**Amendment No. 7****11.03.2023****Sub: Amendment to the Bidding Document**

**Ref.: Notice Inviting Bid ref. HITES/PCD/MCH-AIIMS/11/22-23 dated 09.11.2022 read with Amendment no. 1, 2, 3, 4, 5 & 6 dtd. 12.12.2022, 28.12.2022, 27.01.2023, 10.02.2023, 27.02.2023 & 10.03.2023 respectively and Bid Auto Extensions.**

**SECTION - VII****TECHNICAL SPECIFICATION AND GENERAL POINTS****A. TECHNICAL SPECIFICATION:****Item No. 1 (Tender ID: 2022 HLL 134888 1)****Digital Subtraction Angiography**

**Tender ID: 2022\_HLL\_134888\_1 (Digital Subtraction Angiography)**

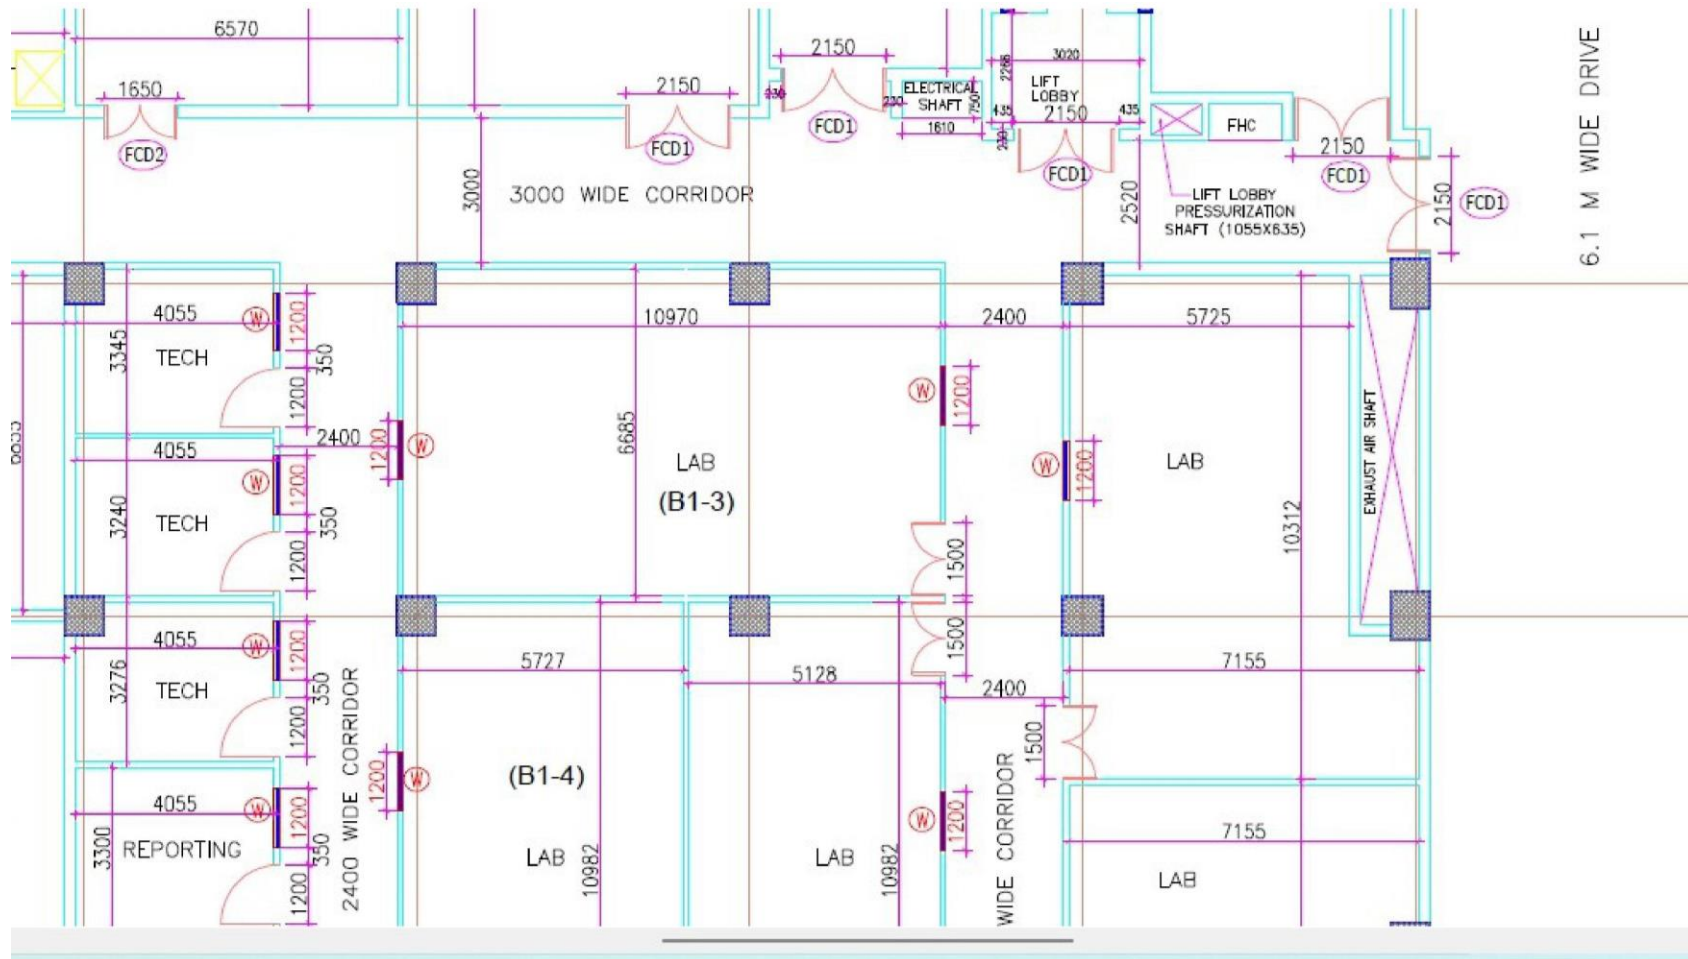
5	Para (The Site Modification Work), Point 3, pg 48	<b>The Site Modification Work - Biplane D.S.A</b> : The cost of Site Modification Work for the area of 1500 sq.ft and Air-conditioning of Tonnage 25 TR (including standby unit) will be considered for Ranking /Evaluation purpose	The Site Modification Work - Biplane D.S.A : The cost of Site Modification Work for the area of <b>1300 sq.ft</b> and Air-conditioning of Tonnage <b>25 TR</b> (including standby unit) will be considered for Ranking /Evaluation purpose
6	BOQ pt 4, pg 52	Air Conditioning: 20 TR	Air Conditioning: <b>25 TR</b>
7	Para BOQ (Miscellaneous ), Point 8, pg 52	Optional items offered should be quoted separately and the price shall be added for bid-ranking purpose. The price should be valid for warranty period	Deleted
8	Para (The Site Modification Work), Point 2.d, pg 48	Patient stretcher and other furniture/ accessory to make the DR centre functional	Deleted

9	NA	<b>Added Para</b>  Para Furnitre, Para <b>m</b> , pg 50-	<b>Patient stretcher-01 No.</b>
10	Para (The Site Modification Work), pg 49	The scope of work includes complete Civil work, Electrical, Plumbing, Furnishing, Air-conditioning and Fire fighting for the installation of DSA system	amended as: The scope of work includes complete Civil work, Electrical, Plumbing, Furnishing, Air-conditioning and <b>Fire detection</b> for the installation of DSA system

<b>Sr. No.</b>	<b>Document Para and Page</b>	<b>Existing Tender Specification</b>	<b>Amended As</b>
11	Para Flooring a.1 , pg 49	600 x 600 mm vitrified tiles with 100 mm tile skirting to match in DSA Examination Room, console room, lobby and patient preparation areas, Radiologist room etc.	600 x 600 mm vitrified tiles with 100 mm tile skirting to match in entire <b>DSA complex</b> apart DSA Exam room, equipment room and <b>UPS room.</b>
12	Para Flooring a.2 , pg 49	50 mm thick cement concrete flooring with Vinyl flooring in Biplane DSA equipment / UPS room.	50 mm thick cement concrete flooring with Vinyl flooring in Biplane DSA <b>Exam room</b> , equipment / UPS room.
13	Para (AIR CONDITIONING), pg 50	Ventilation is required in toilet	Deleted
14	Para (Furniture) point K, pg 50	Any other furniture item as per requirement	Deleted
15	Para BOQ, Point 19, pg 52	Lead protected viewing glass (Size: 150cm X 90 cm)-1 No	Lead protected viewing glass (Size: 150 cm X <b>100 cm</b> ); 1 No

16	Para (Components of Site Modification Work), point 52, pg 52	Air Conditioning-20 TR	Air Conditioning-25 TR
17	BOQ Para 6(Components), pg 52	Miscellaneous items : 1Set	Deleted
18	Para (Site Modification Work), page 49	The actual area of site modification work works done will be considered for payment, based on the unit rates and site measurements	The actual area of site modification work done will be considered for payment on prorata basis, based on the unit rates and site measurements.
19	Para (Biplane D.S.A site) page 49	Added Para	Recovery room
20	Para BOQ (Miscellaneous), Point 8.a , pg 52	4D DSA	Deleted
21	Para BOQ (Miscellaneous), Point 8.b , pg 52	Software for 4D DSA	Deleted
